Multiple Profiles for EPoC – Part II

IEEE 802.3bn – Multiple Profile ad-hoc

11 January 2013

1. Scheduling – DS Multipoint MAC Control (77.2.2)

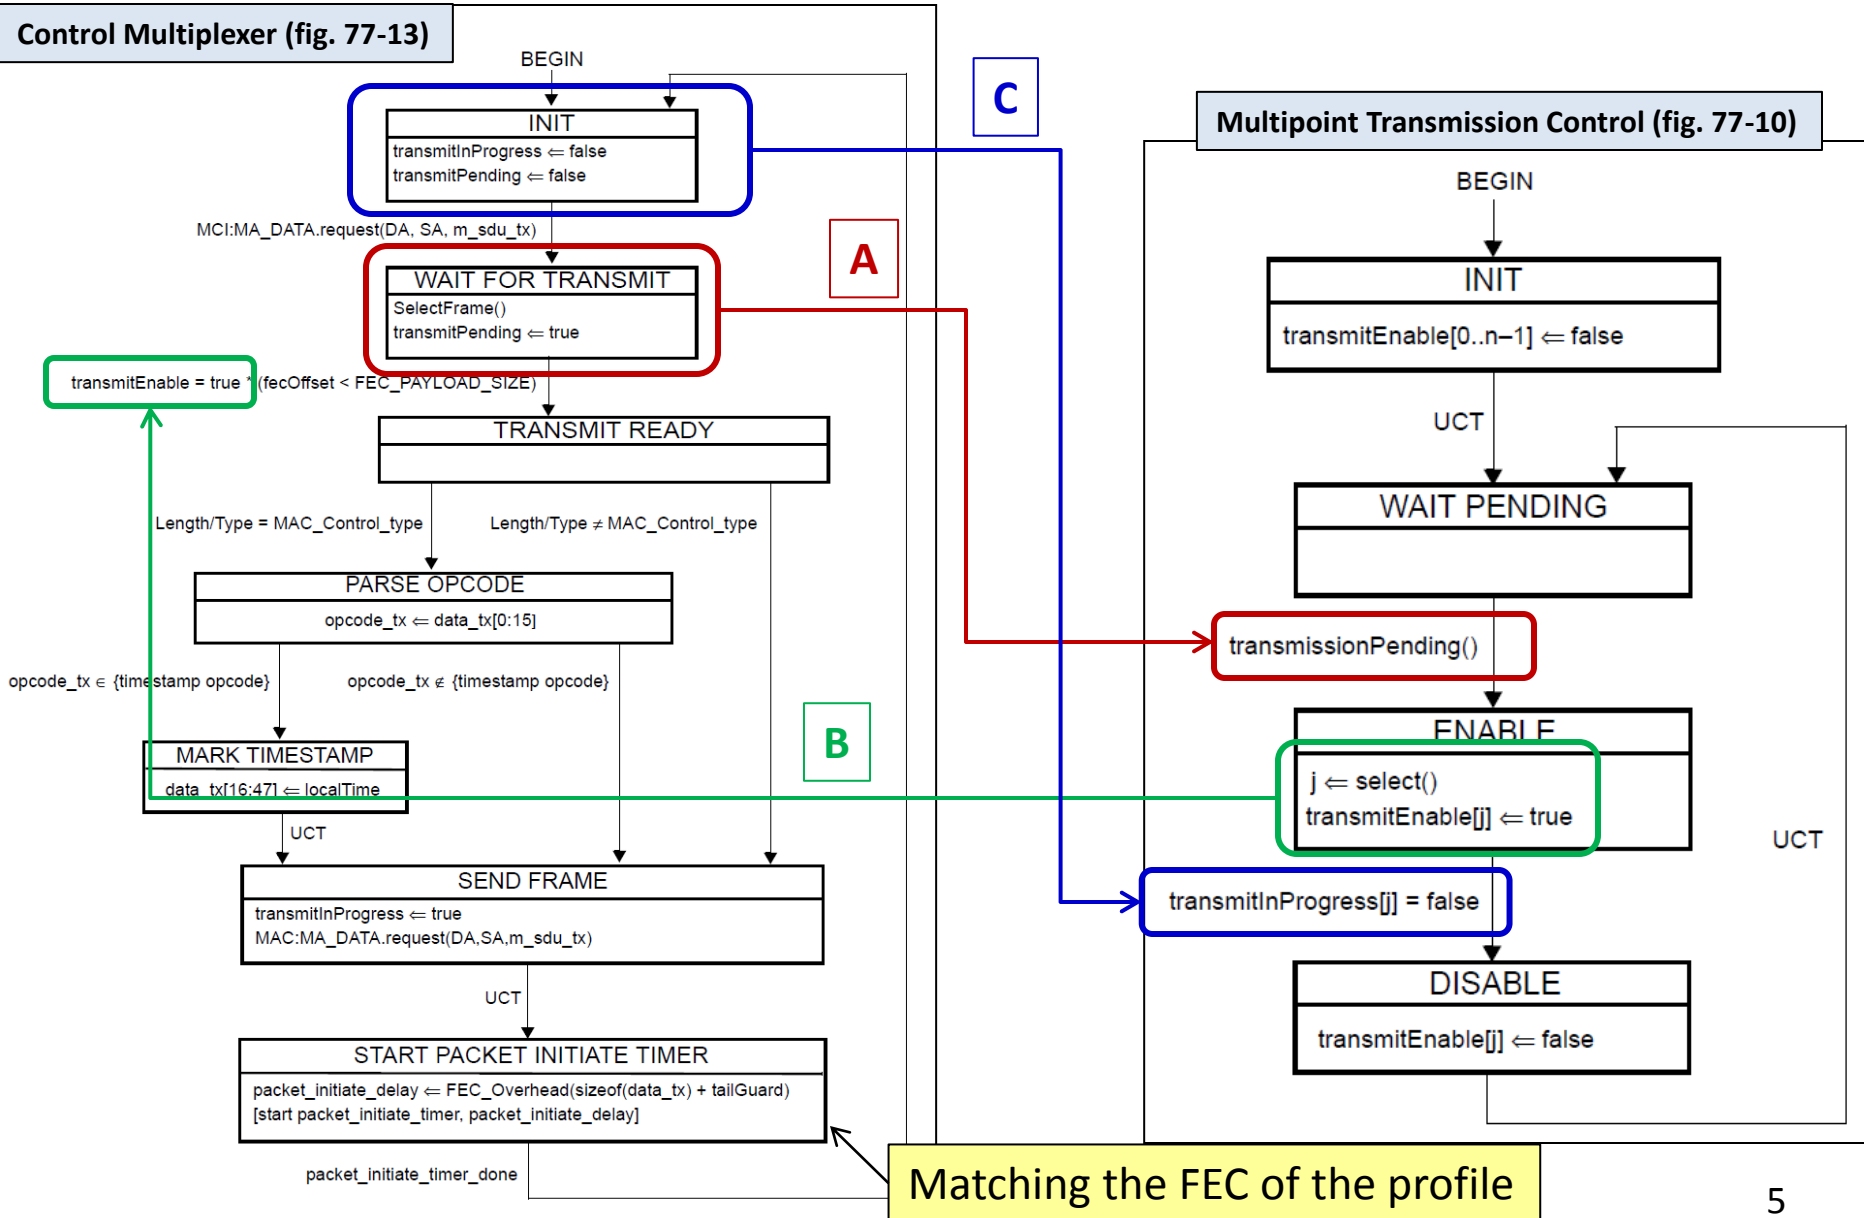
- [Q2 – from Ed] In the current solution, the downstream MAC/PHY is a pass through device. There isn’t shuffling of packets to group them. The shuffling is not reversed on the output so a packet is jitter. The scheduler has no definition and in fact, it does nothing. The proposed solution requires adding scheduler functionality that doesn’t exist. It is not compatible for that reason.

- **[A2 – QCOM]: please refer to slides 5 and 6: the specification clearly mention scheduler functionality in section 77.2.1, which is implementation dependent and accomplish for DS via a proper algorithm that is behind the function *select()*. That function decides which MAC Client to serve in case multiple clients request to transmit.**

1. Scheduling – DS Multipoint MAC Control

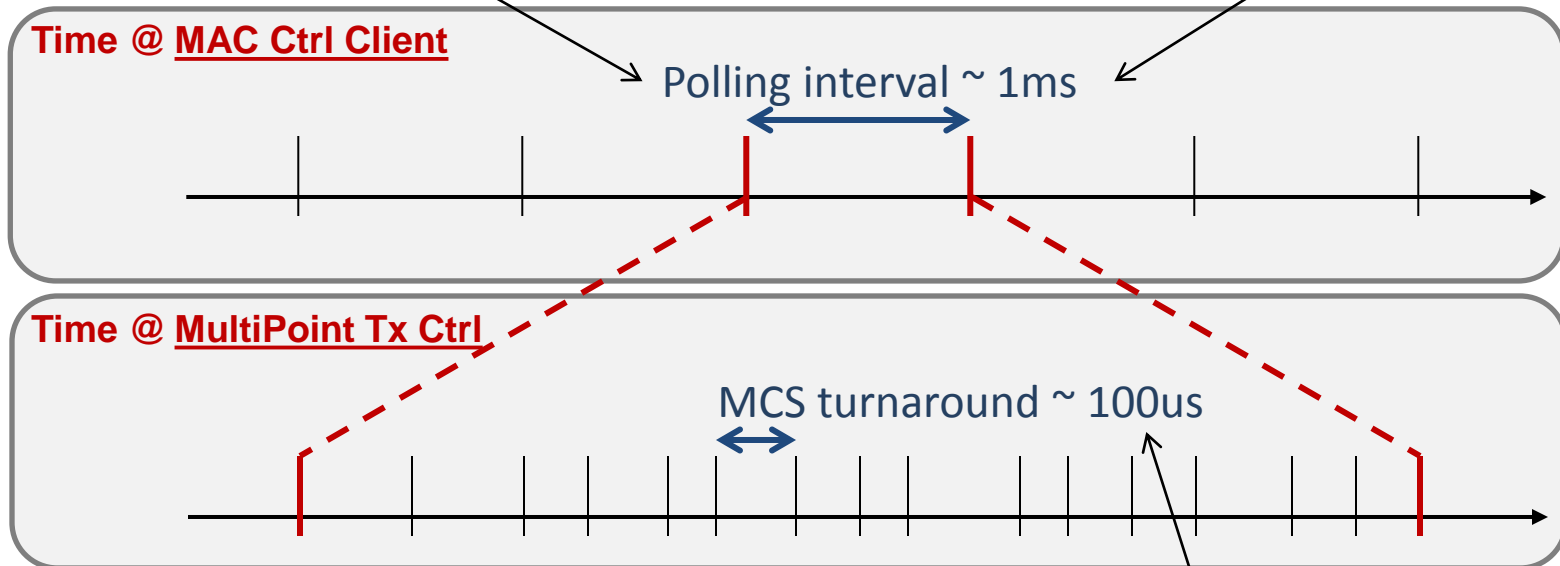
- [Q4 – from Ed] When you shuffle packets, the packets are jittered on the downstream. They do not enter and exit with the same delay. If you timestamp the packets and add a play out buffer at the output, you can remove the jitter. This adds delay but doesn't add the jitter.

- [Q5 – from Ed] It is expected that the MAC/PHY has a fixed delay and performance. This solution varies the delay (by shuffling packets between stations) and data rate based on the other traffic. The priority of my traffic is not used to determine the order to the output.

- [Q6 – from Ed] I don't know how to explain this. The GATE frame comes out based on the scheduler. If it is not going in the MMP block that is currently going out, the MMP block needs to break up the FEC block or delay the GATE until the proper FEC block comes around. It is either very inefficient or it adds a millisecond or more to the schedulers delay to generate a GATE. This goes into the REPORT/GATE loop.

- **[A4/5 – QCOM]: Please see slide 5, shuffling is between users (not packet belonging to the same flow – they remain in the original order) and applied before timestamp at MPCP – there is therefore no jitter and all packets enters XGMII and exits that after a fixed delay as in the current system. If we were to shuffle packets directly below the XGMII interface, then jitter may occur and would have to be addressed.**

- **[A6 – QCOM]: Please see slides 5 and 8: the GATE packets are input to the Control Multiplexer of the CLT and are prioritized over data packets as in the current spec – this is achieved by the function *SelectFrame()*. The Multipoint Transmission Control only receives a *transmitPending* signal and it does not know whether there is a GATE or data, it simply schedule MAC Clients requesting to transmit based on certain policy (example round robin over a scheduling cycle) – this is the same as today**

- **Only once a user is selected by *select()* and enabled to transmit, the selected frame in its Control Multiplexer will timestamp the packet – this happens for GATE messages as well for data packets.**
